November 9, 2022

**RE: Heritage Shores — Phase 5/Villas at Bridgeville
Tax ID No. 131-14.00-44.00
Final Development Plan & RPC Amendment Review**

At the Town's request, Wallace Montgomery (WM) has reviewed the Final Development Plan for the above-referenced project, consisting of the following components:

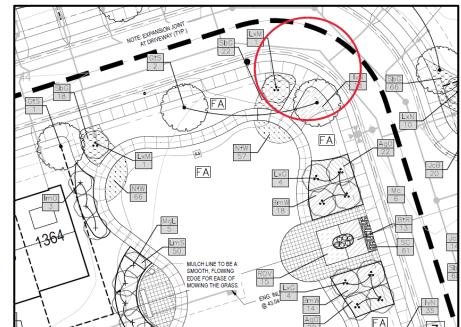
***Per §234-37F, the Town Commissioners may adjust property development standards applicable to residential planned communities for phased development, as a part of RPC Final Development Plan approval for such phase.**

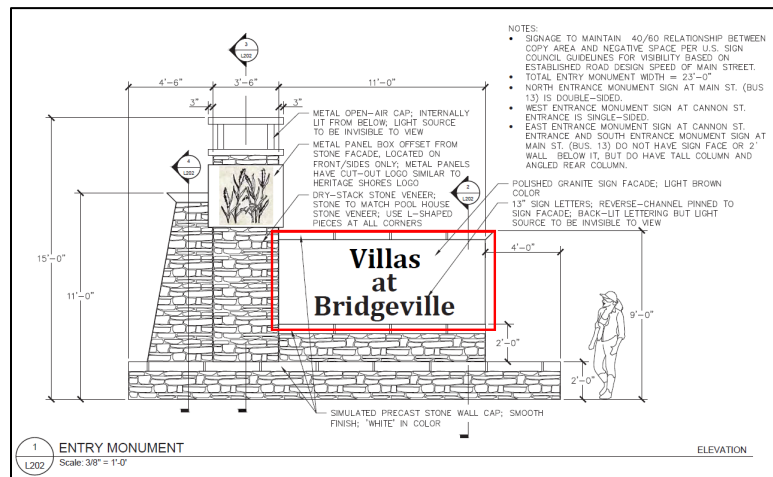
Should an ADA-compliant curb ramp be provided along ROW Curve 9:
